# HISTORIC AND DESIGN REVIEW COMMISSION

**HDRC CASE NO:** 2022-239  
**ADDRESS:** 702 HAYS ST  
**LEGAL DESCRIPTION:** NCB 540 BLK 11 LOT A16  
**ZONING:** R-5, H  
**CITY COUNCIL DIST.:** 2  
**DISTRICT:** Dignowity Hill Historic District  
**APPLICANT:** Kuba Zarobkiewicz/ZAROBKIEWICZ KUBA  
**OWNER:** Kuba Zarobkiewicz/ZAROBKIEWICZ KUBA  
**TYPE OF WORK:** Construction of a rear addition, exterior modifications, window replacement, rehabilitation, roofing material change  
**APPLICATION RECEIVED:** May 06, 2022  
**60-DAY REVIEW:** Not applicable due to City Council Emergency Orders  
**CASE MANAGER:** Edward Hall

**Historic and Design Review Commission**  
***Design Review Committee Report***

NEW RESIDENCE ADDITION & STUDIO UNIT FOR  
KUBA & KIMBERLY ZAROBKIEWICZ  
702 HAYS ST.  
SAN ANTONIO, TEXAS 78202

## FLOOR PLAN MAIN HOUSE

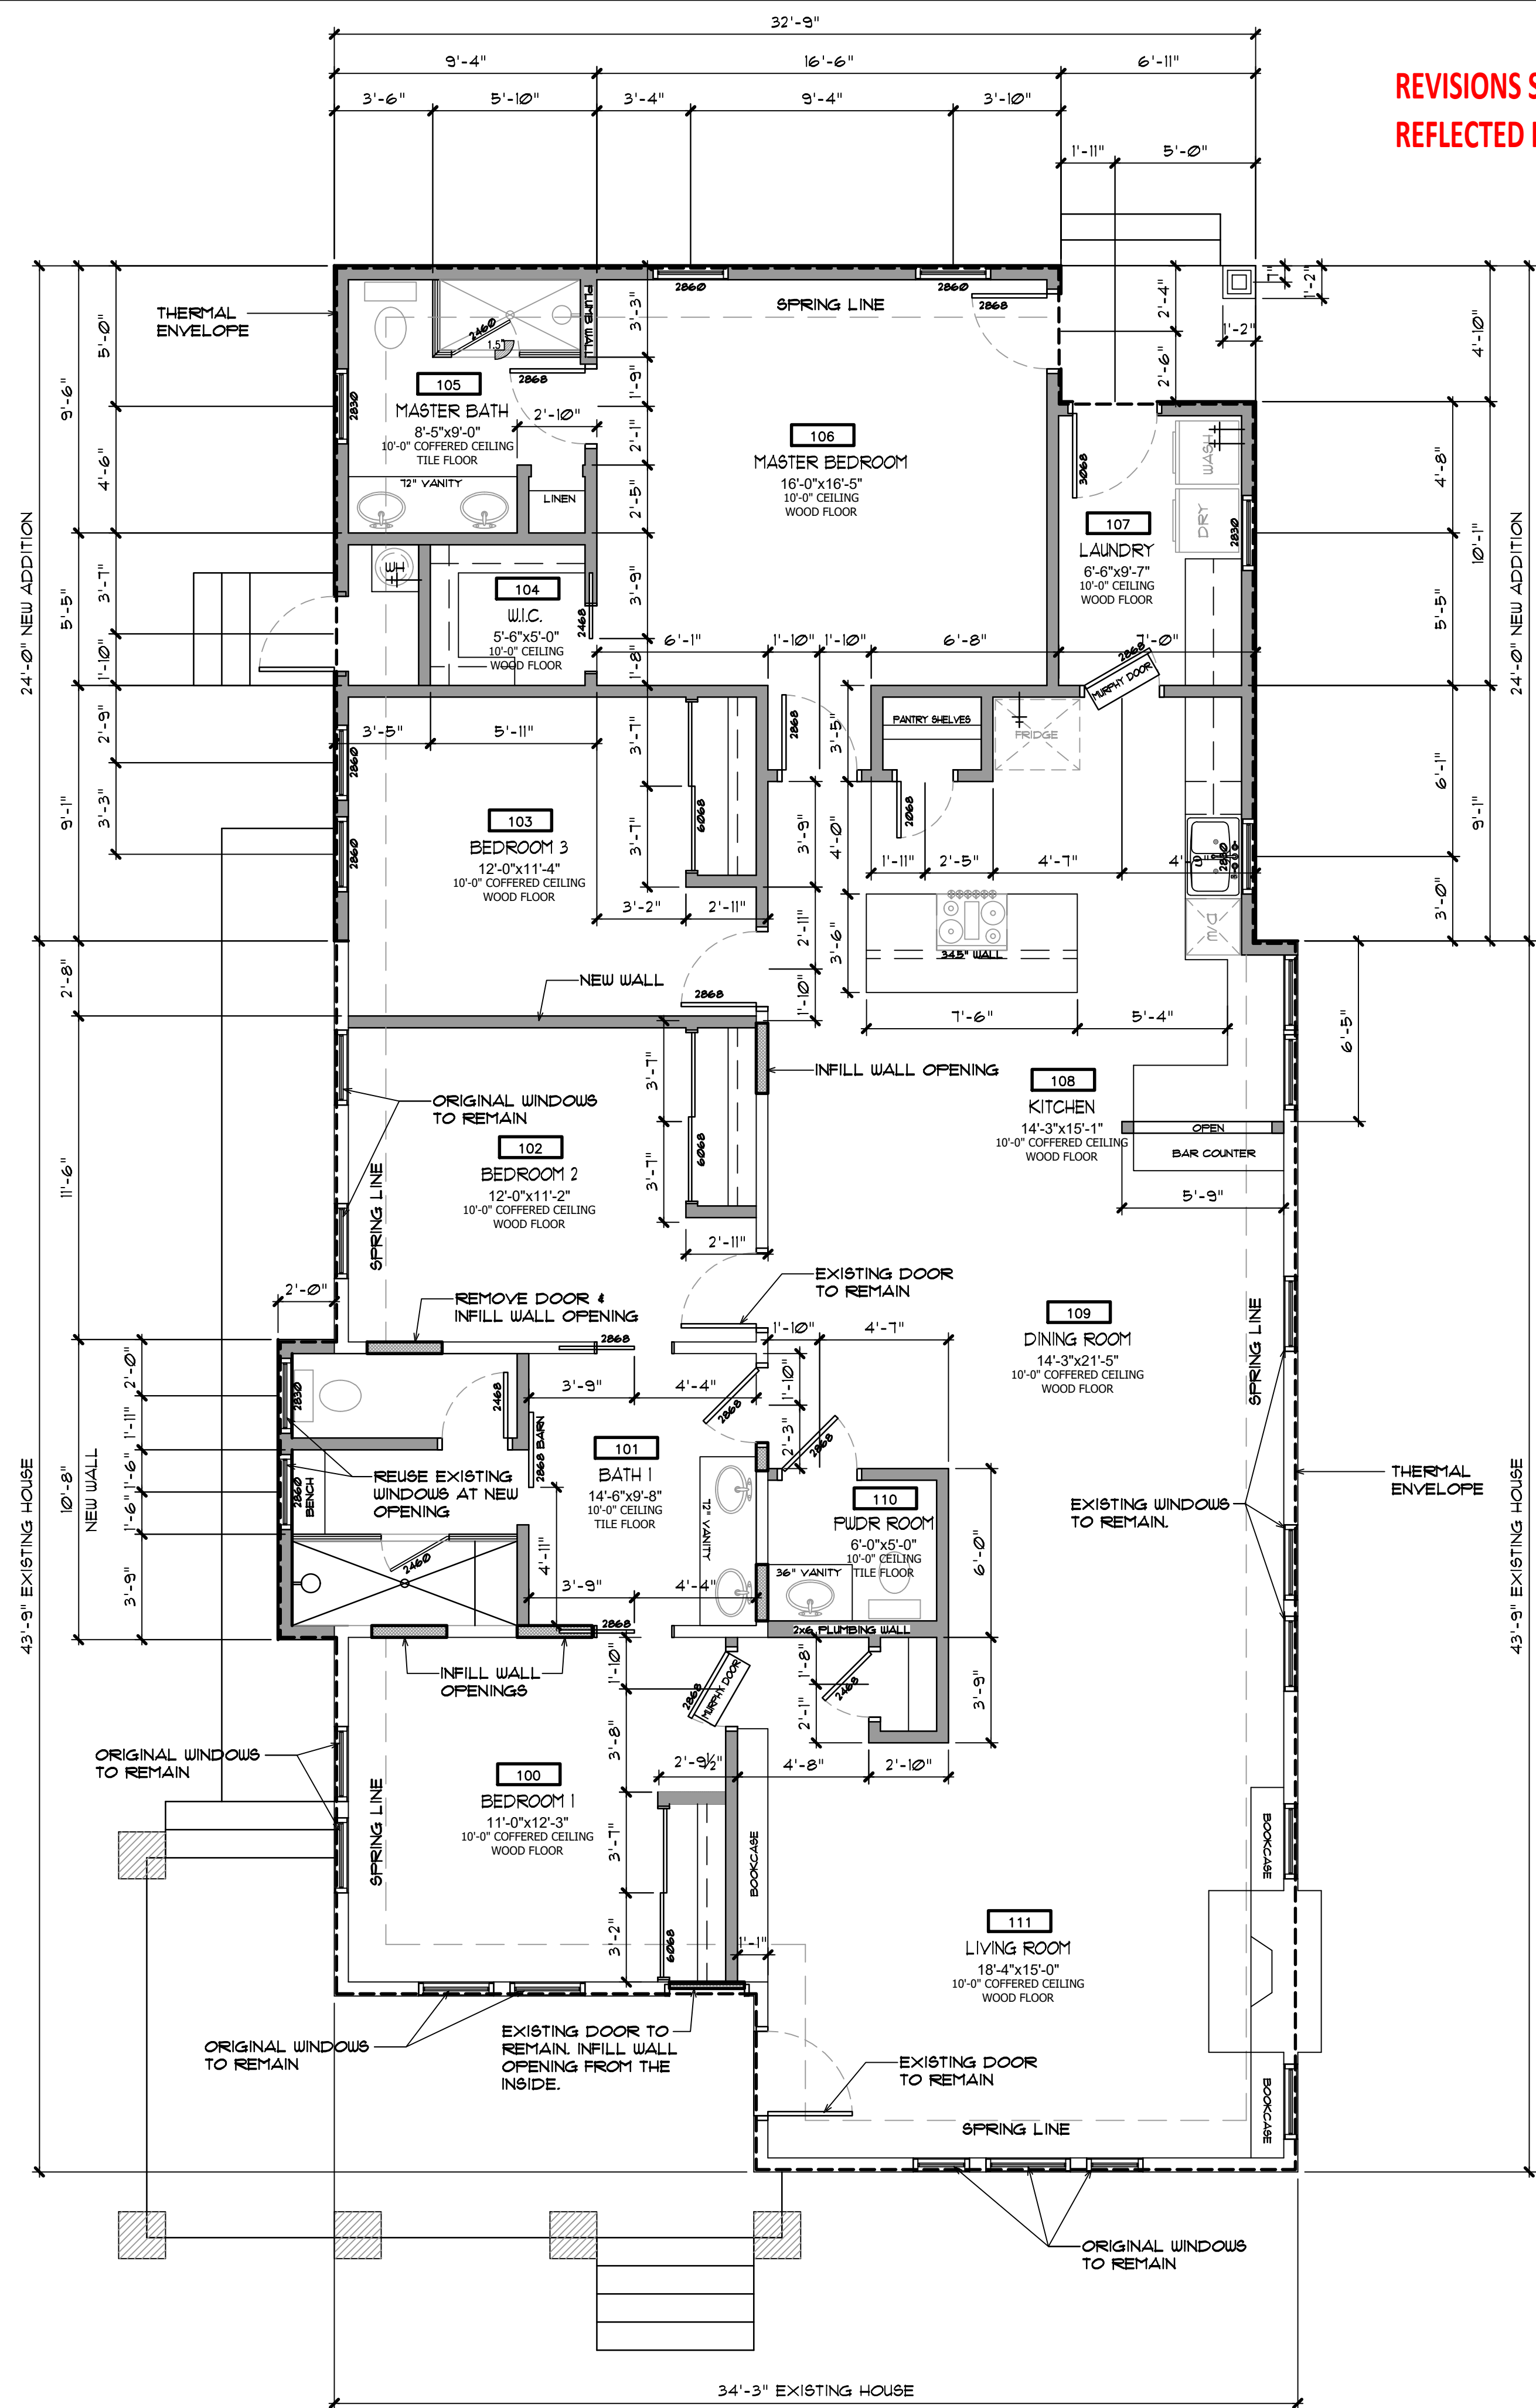
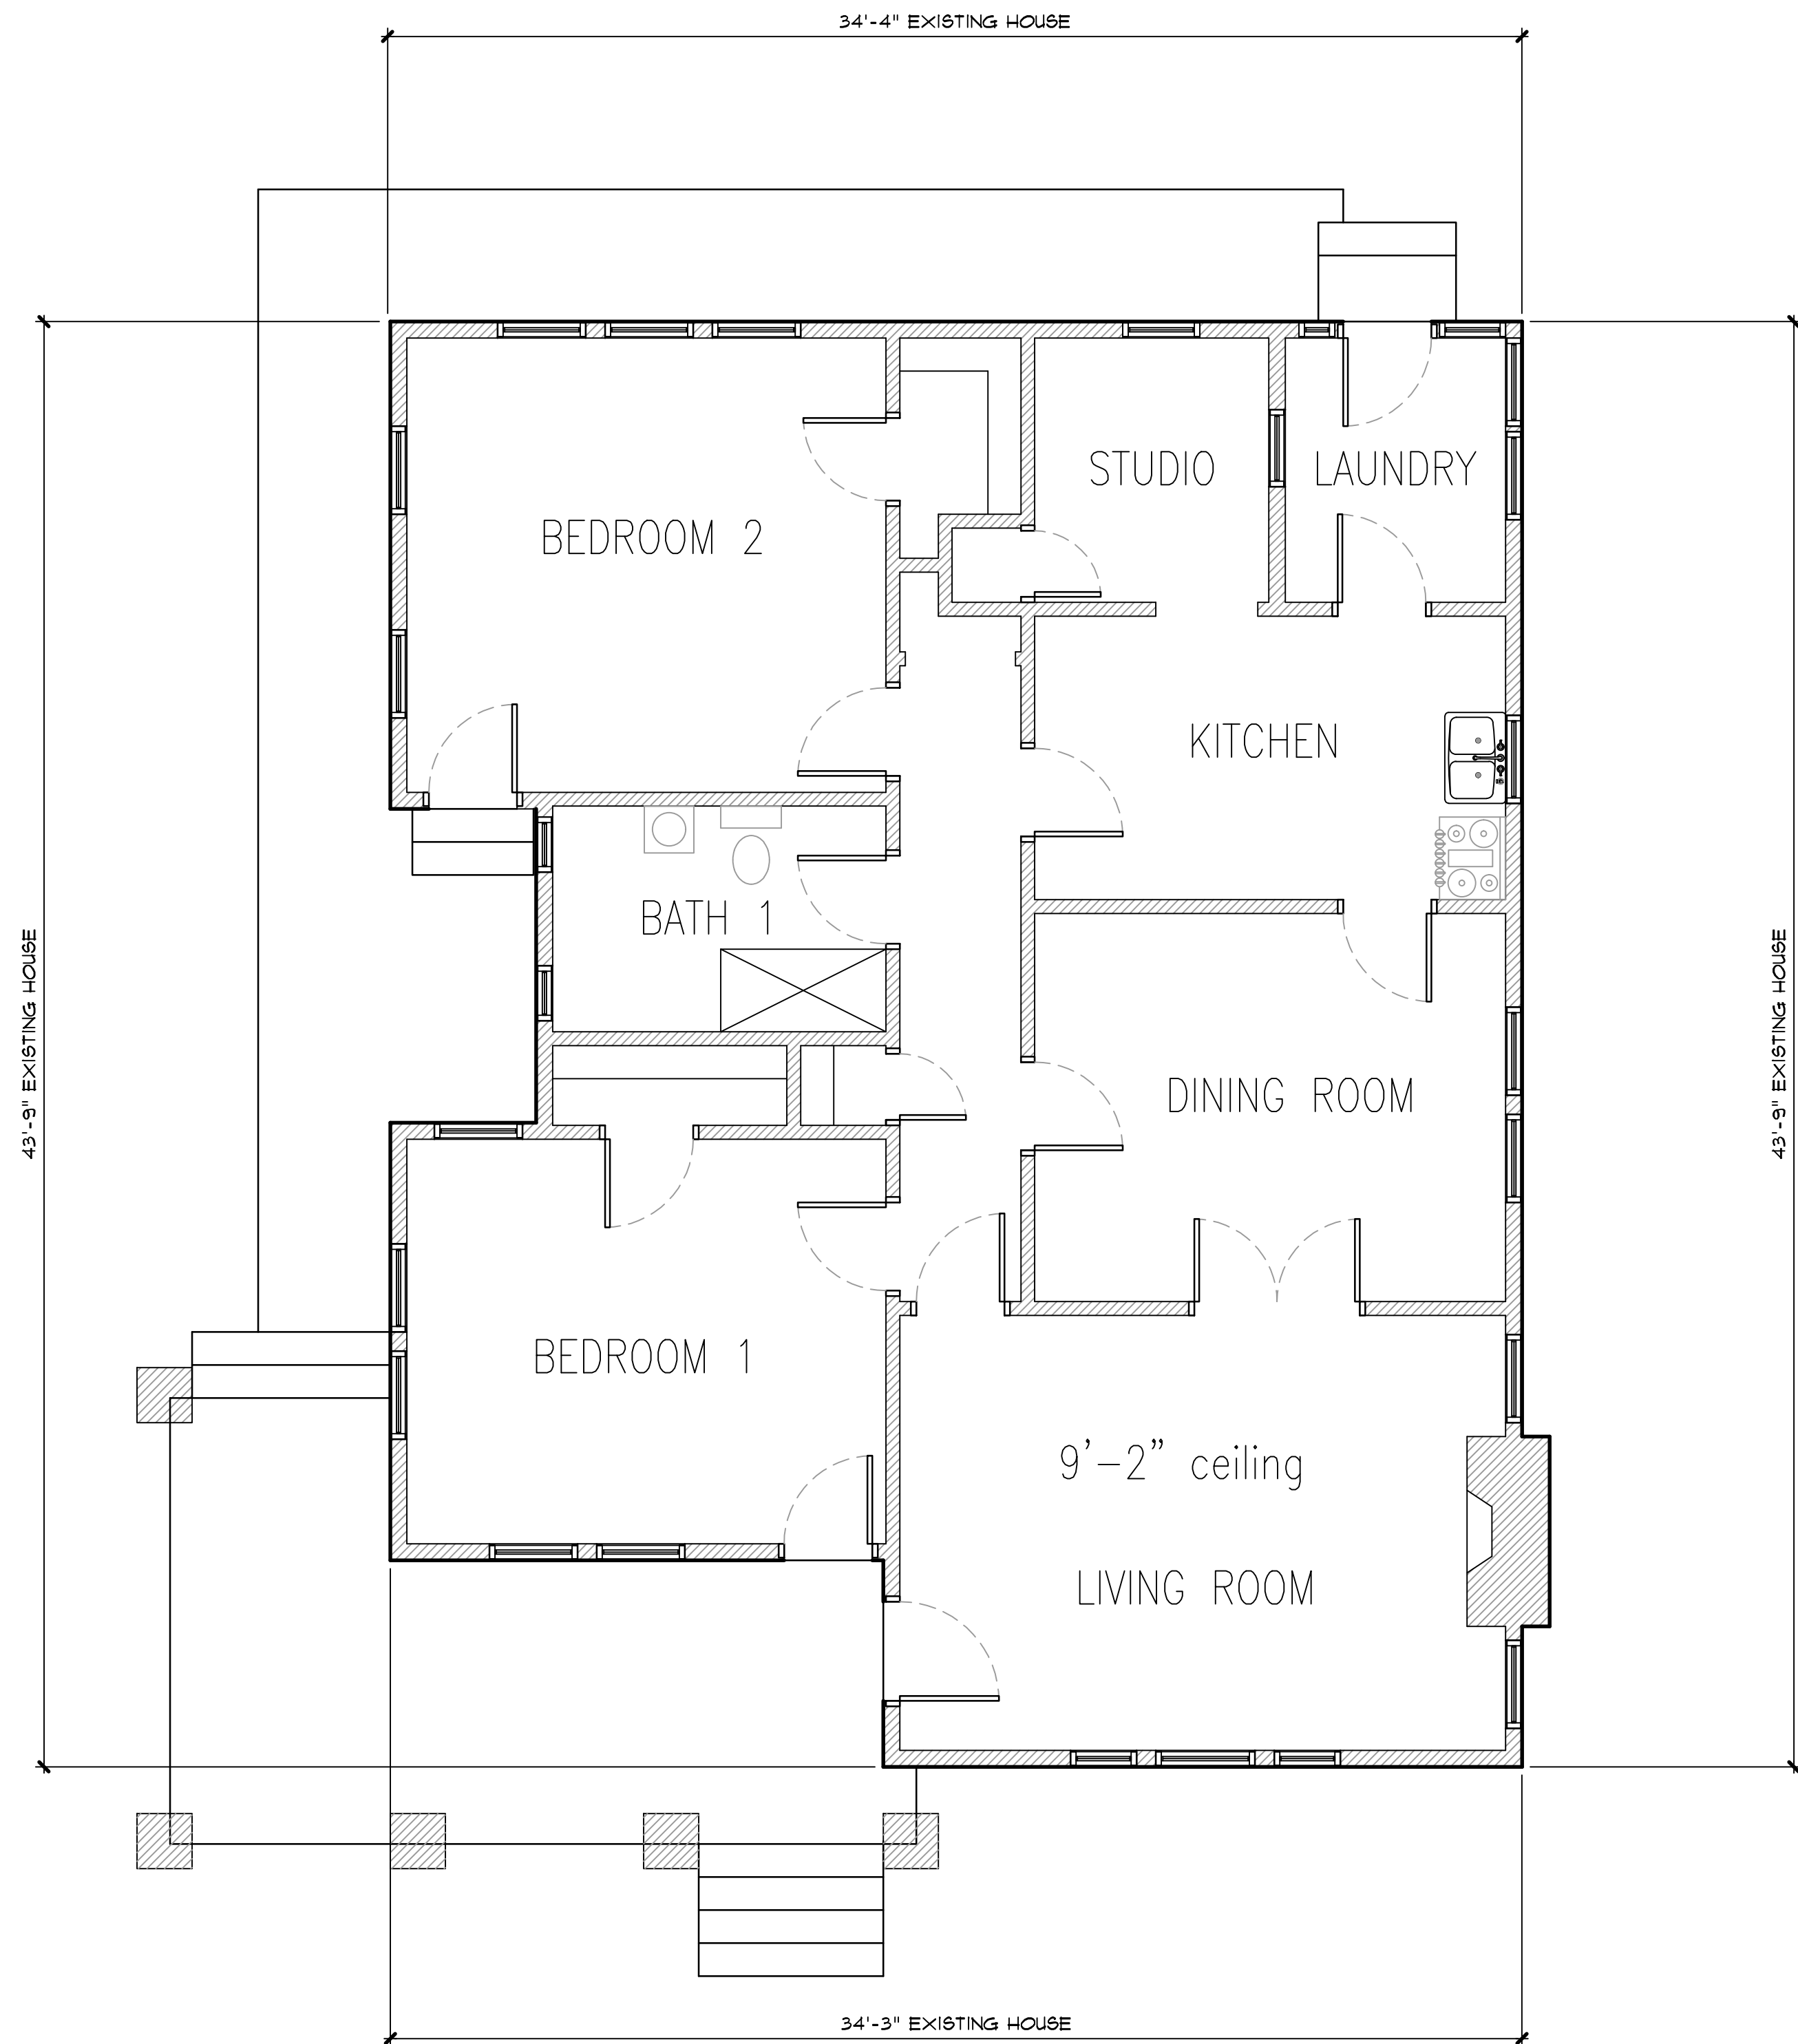
REVISIONS SUBMITTED TO ADDRESS COMMENTS FROM OHP STAFF AND THE DRC - THESE REVISIONS ARE NOT REFLECTED IN STAFF'S FINDINGS OR RECOMMENDATIONS.
